Title & Document Type: **8405A Vector Voltmeter Operating and Service Manual**

Manual Part Number: **08405-90024**

Revision Date: **May 1971**

8405A

Figure 7-17(b). Schematic Diagram, Automatic Phase Control Section (Part 2) Sampling Pulse Generator

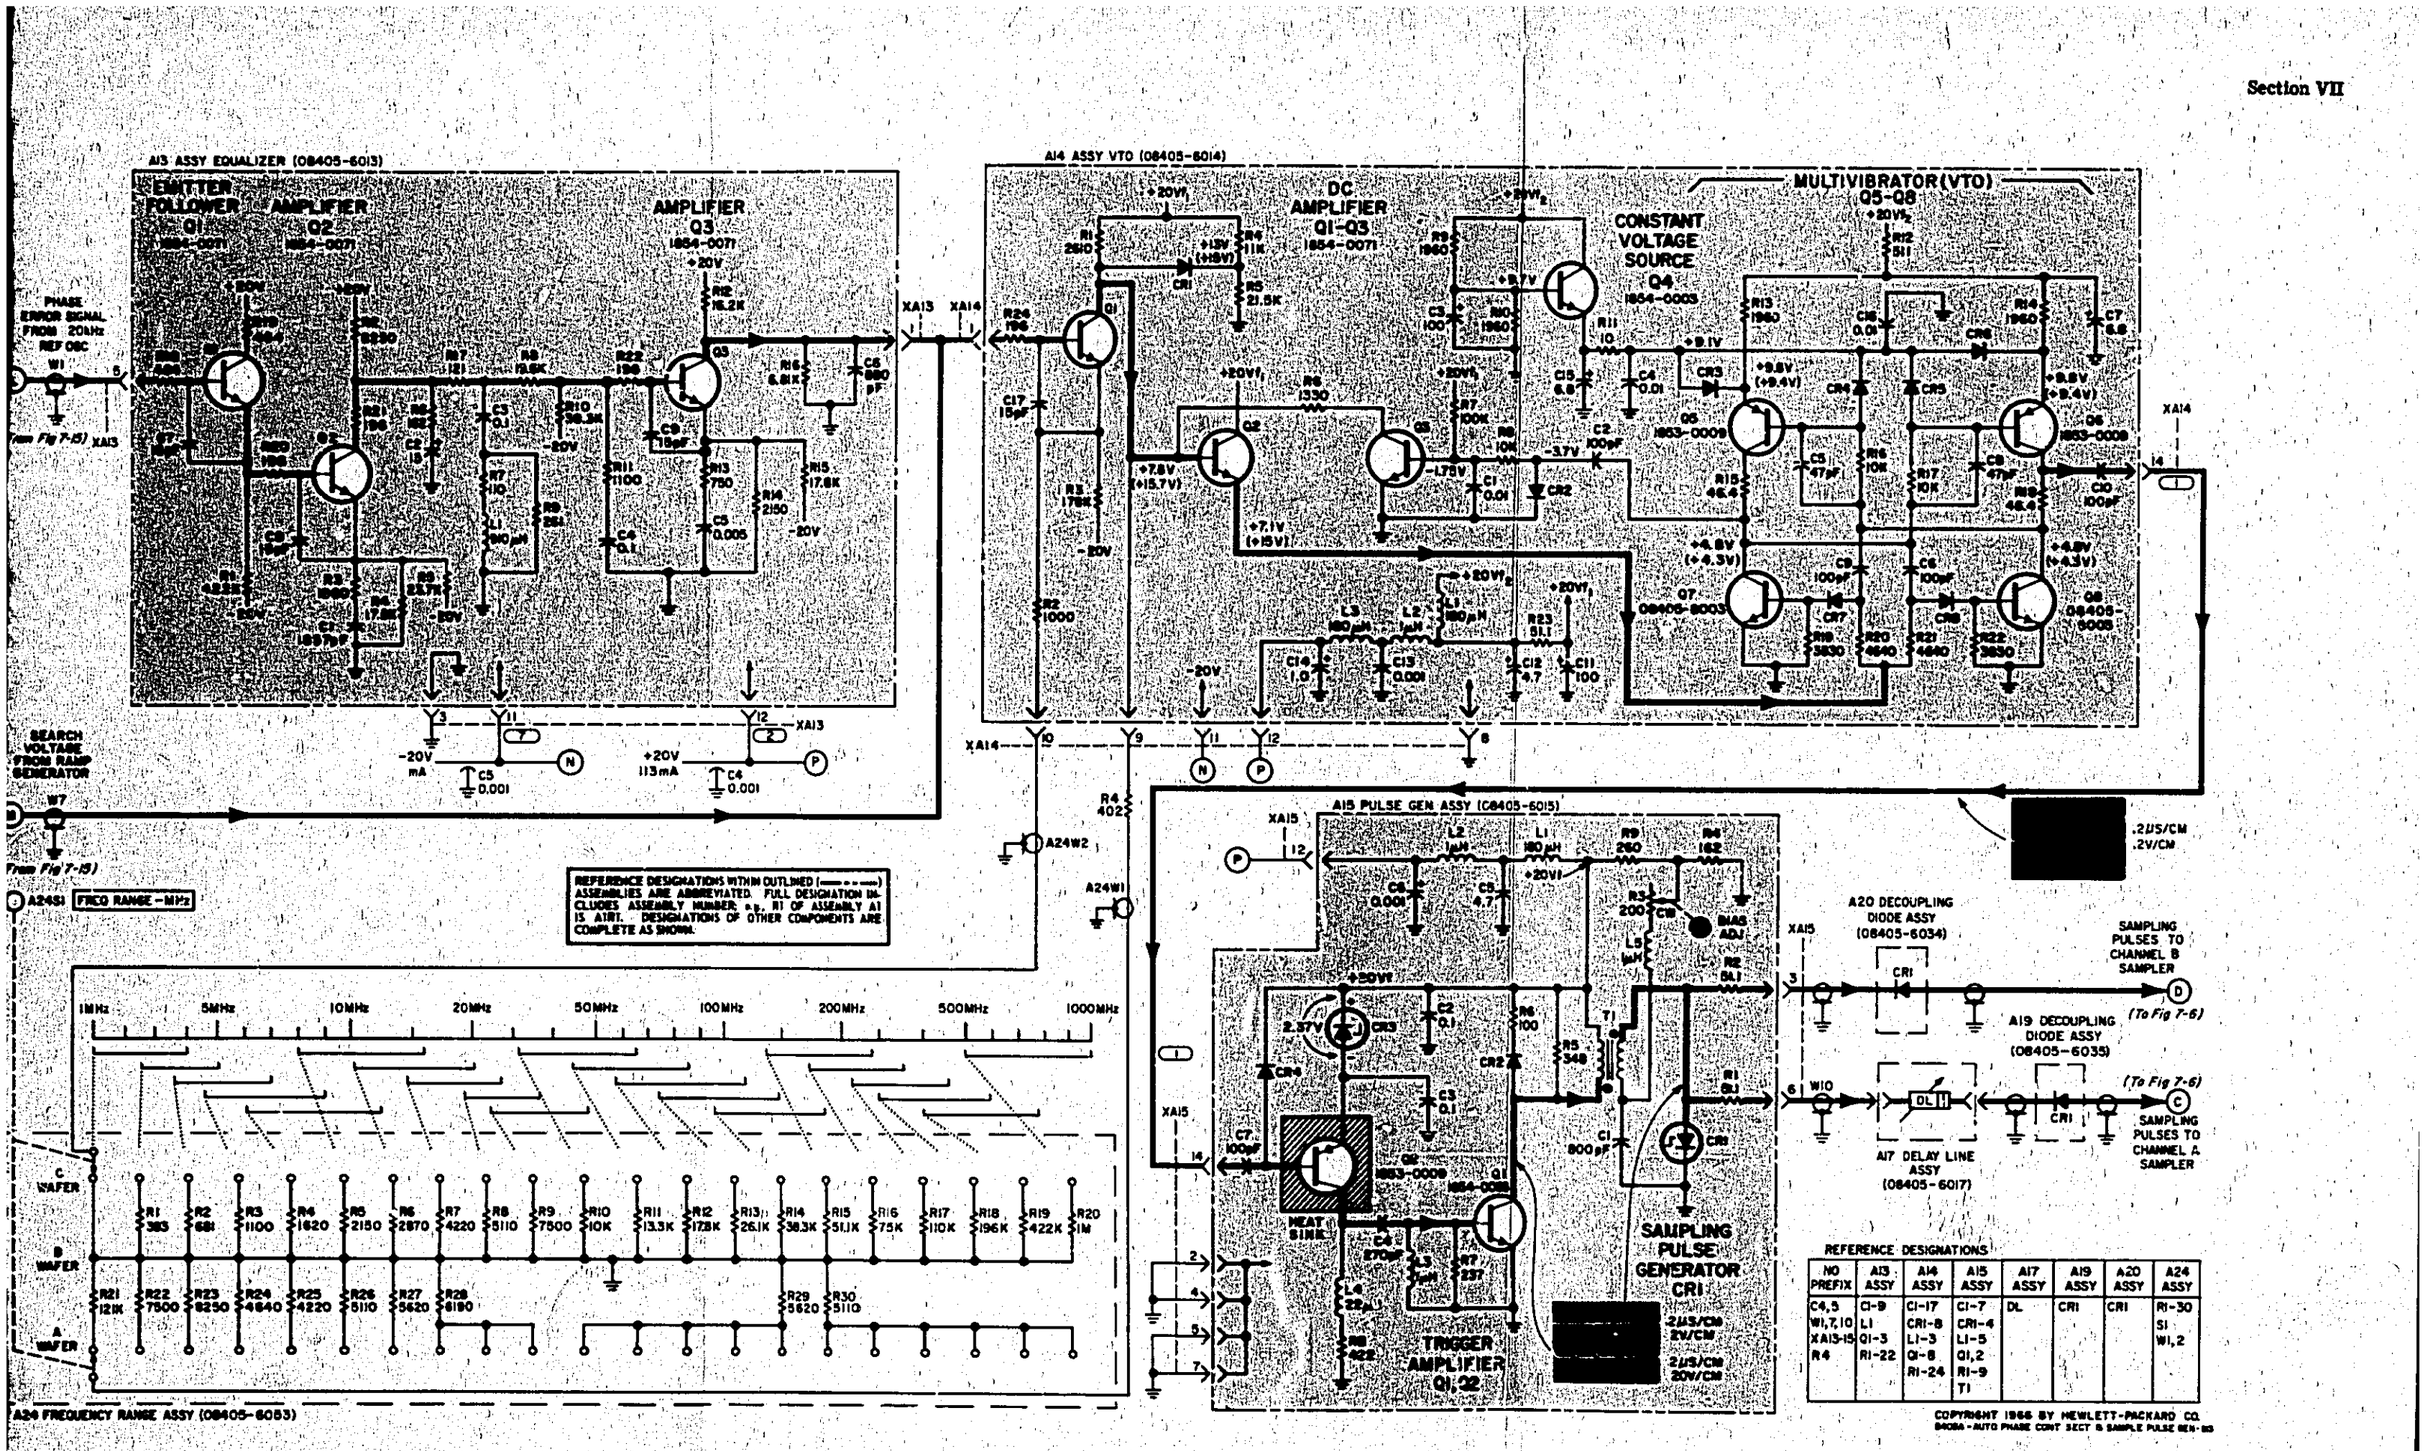
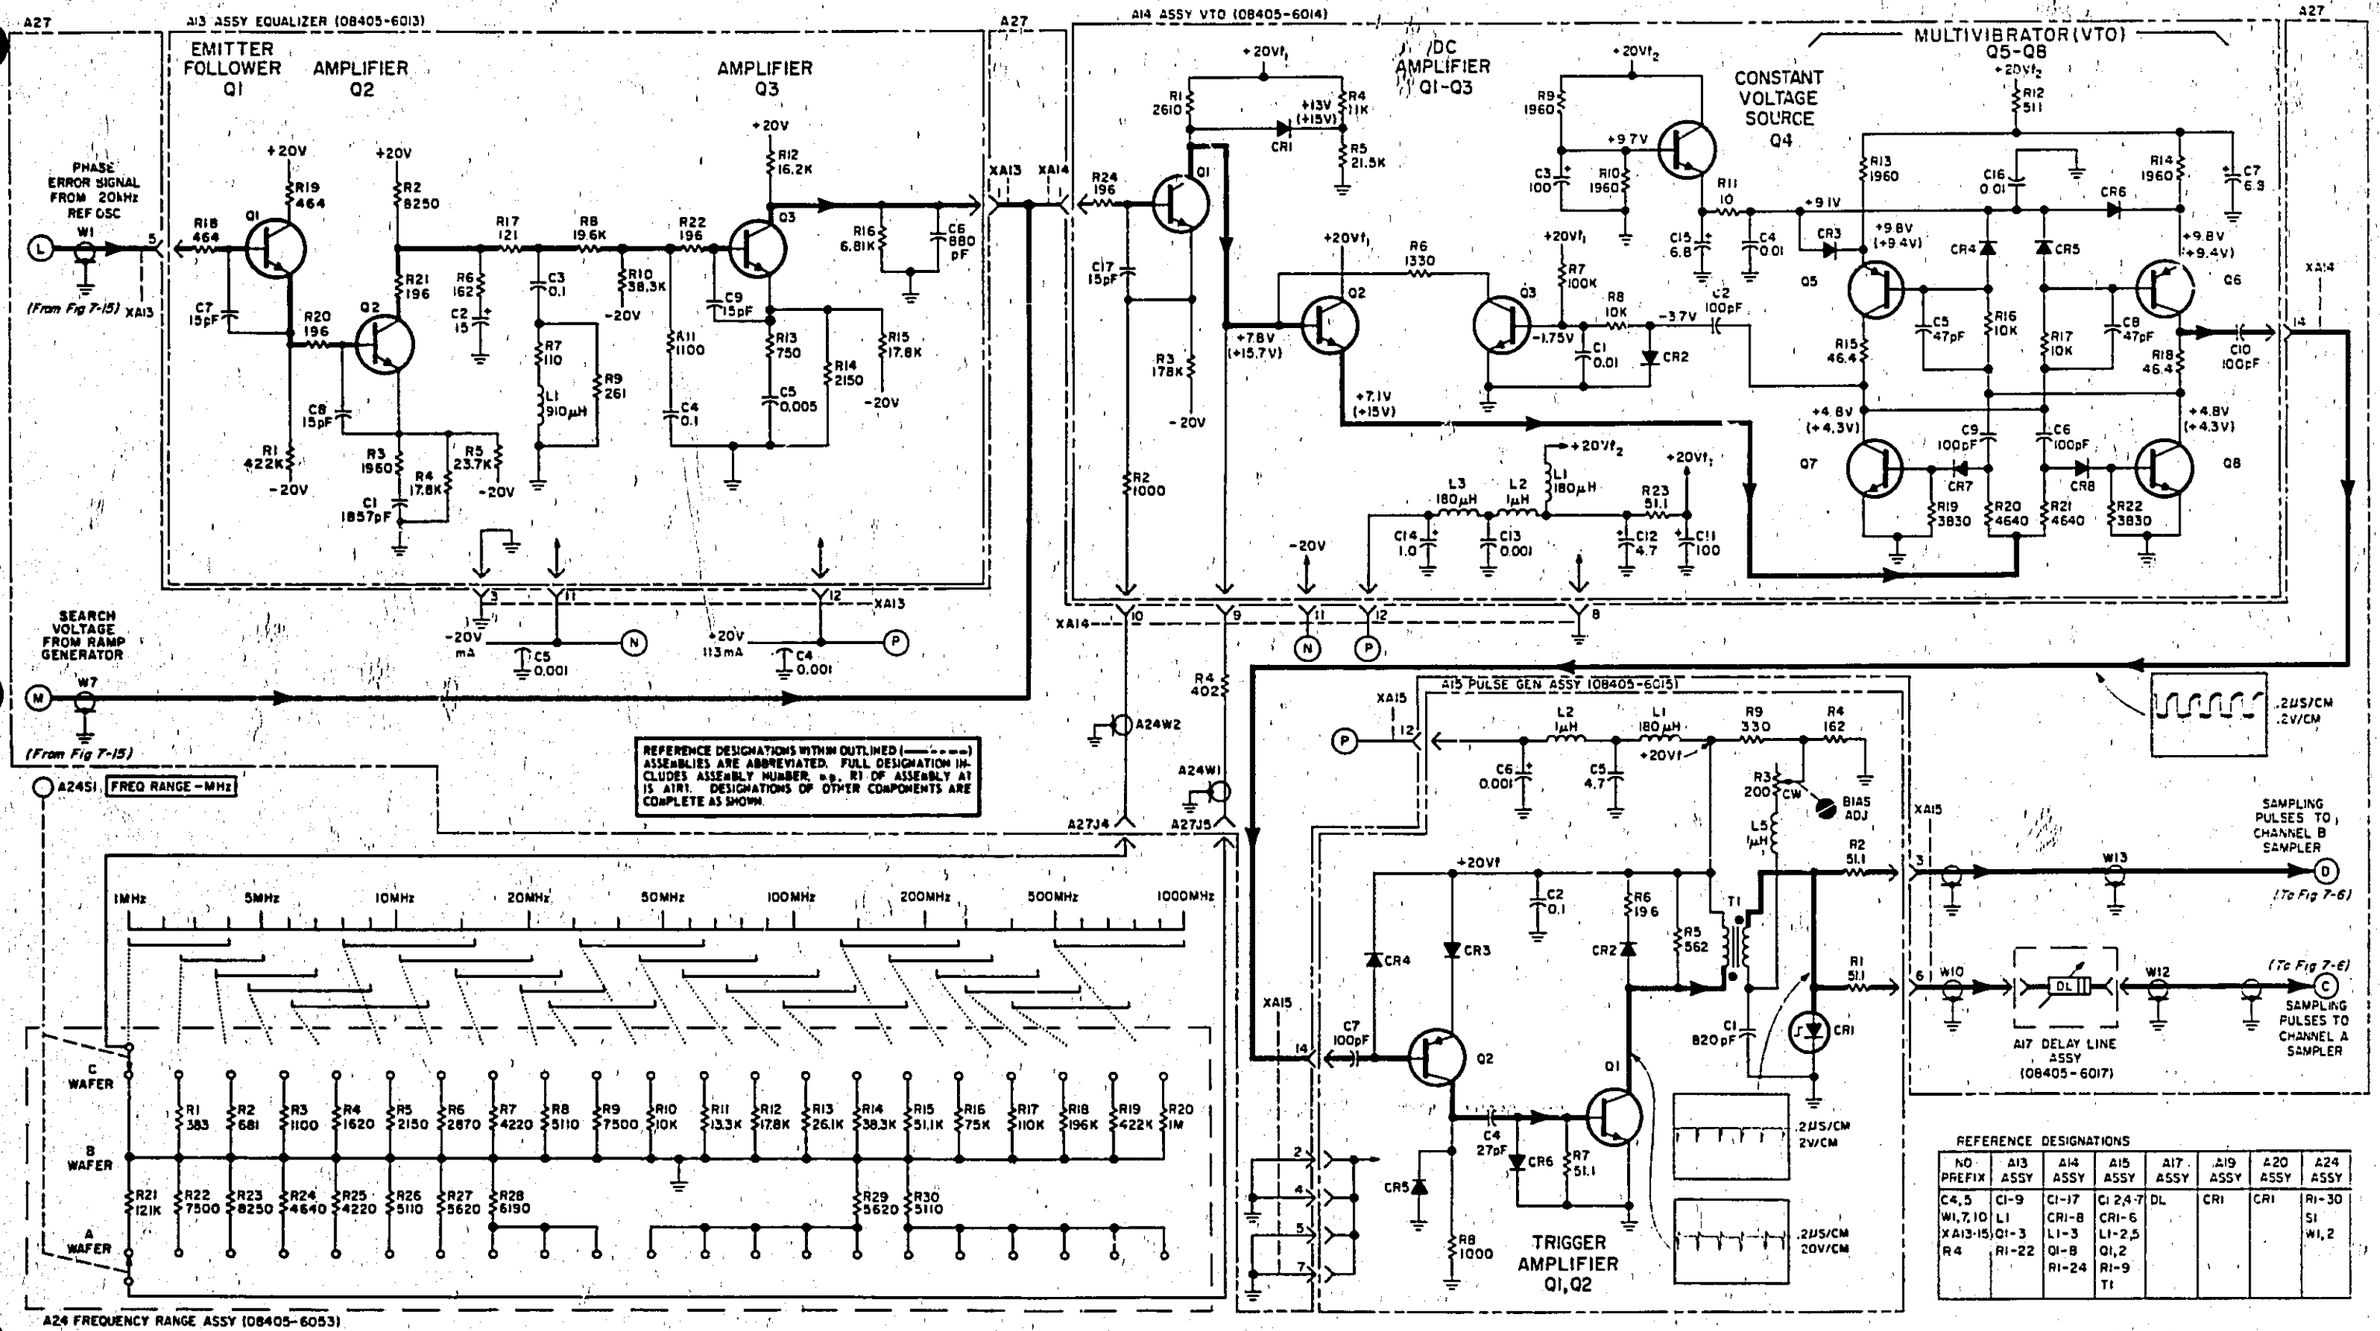
Figure 7-17(b):
Change A19 to 08405-60072.
Add A19CR2 in series with A19CR1, cathode toward A17.
Change A20 to 08405-60071.
Add A20CR2 in series with A20CR1, cathode toward XA15-3.

Figure 7-17(b):
Change A15R9 to 333 Ohms.

Figure 7-17(a):
Replace the part number 08405-6053 which identifies the A24 Frequency Range Assy with this note: See Table 6-1 for the current assembly number.
Figure 7-17(b) of Change 17:
Replace the part nubmer 08405-6053 which identifies the A24 Frequency Range Assy with this note: See Table 6-1 for the current assembly number.

PAGE 7-17:
Figure 7-17(a):
Replace the part number 08405-6053 which identifies the A24 Frequency Range Assy with this note: See Table 6-1 for the current assembly number.
Figure 7-17(b) of Change 17:
Replace the part number 08405-6053 which identifies the A24 Frequency Range Assy with this note: See Table 6-1 for the current assembly number.

Figure 7-17(b):
Replace Figure 7-17(b) with Figure 7-17(b) in this change sheet (CHANGE 17)
